**ASHA Consulting (Pty) Ltd**  
40 Brassie Street  
Lakeside  
7945

11 April 2019

**AMENDMENT TO ENVIRONMENTAL AUTHORISATION FOR KOKERBOOM 1 WIND ENERGY FACILITY:  
HERITAGE COMMENT**

**Figure 1:** Revised layout as contemplated in the amendment application. Blue dots denote turbines, red lines are roads, orange lines are overhead MV cabling, blue line is HV power line. Heritage resources are shown by red circles and the survey tracks are in green.

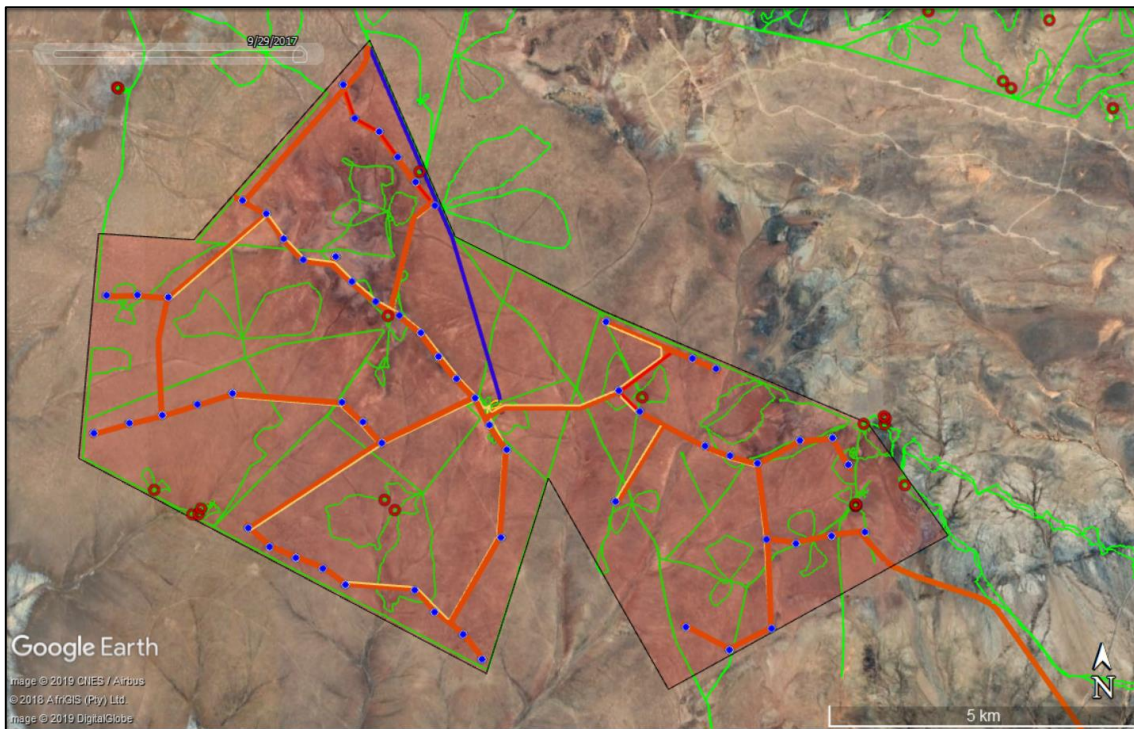
I have examined the new layout relative to the known archaeological resources (Figure 1). One archaeological find lies about 60 m from the power line route but is a scatter of historical ceramic fragments of very low significance and requires no mitigation. All other sites are well away from the layout. The minimum distance between significant archaeological sites and the revised layout is 400 m (Figure 2). As such, no impacts to these sites are expected at all. Because the survey aimed to visit all landscape features where archaeology would be expected and to sample the remaining parts of the landscape, a good understanding of site distribution has been gained and it is considered very unlikely that further significant resources would be present anywhere within the project site.

The proposed amendments will not affect the nature or significance of the impacts previously assessed. No additional fieldwork or reporting is required to assess the proposed amendments, and all mitigation measures previously recommended remain valid. I therefore support the amendment of the environmental authorisation but, once more, subject to the following conditions as contained in the original assessment:

**Figure 2:** Revised layout with only the significant archaeological sites shown. Note that more than one sensitive occurrence occurs at 291 and 391.

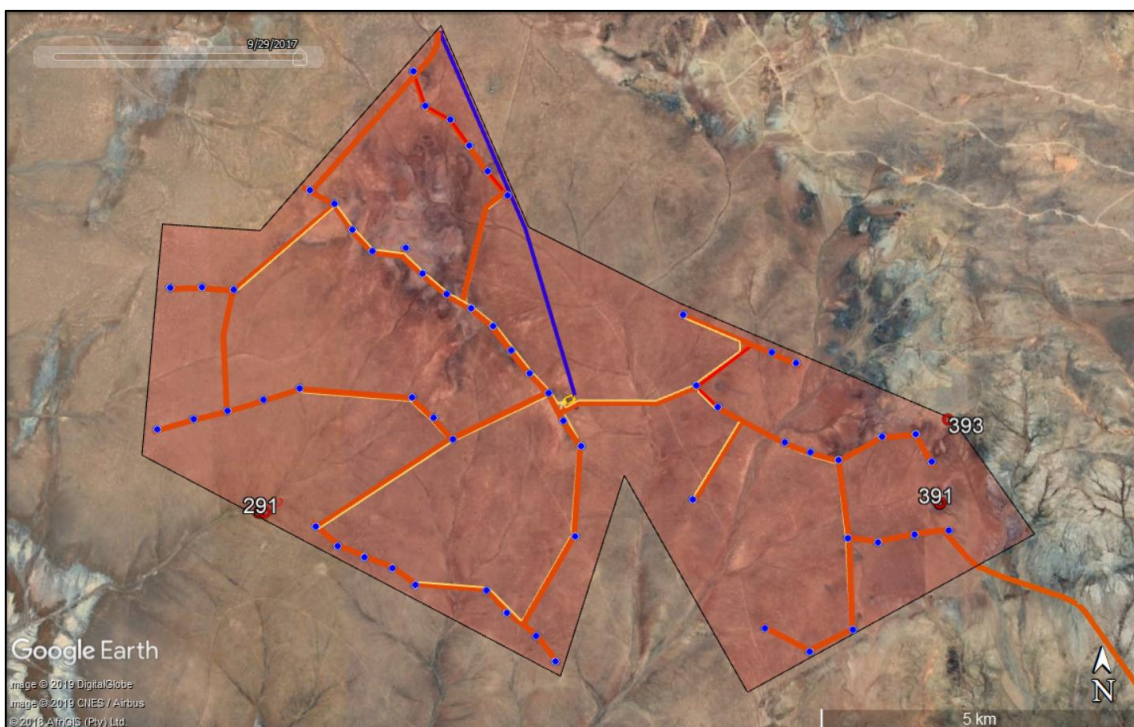
It is noted that the new layout respects all known heritage resources (all of them being archaeological sites). Furthermore, the palaeontological specialist study by Dr John Almond showed that the project site was of low palaeontological sensitivity and that there were no areas that required avoidance.
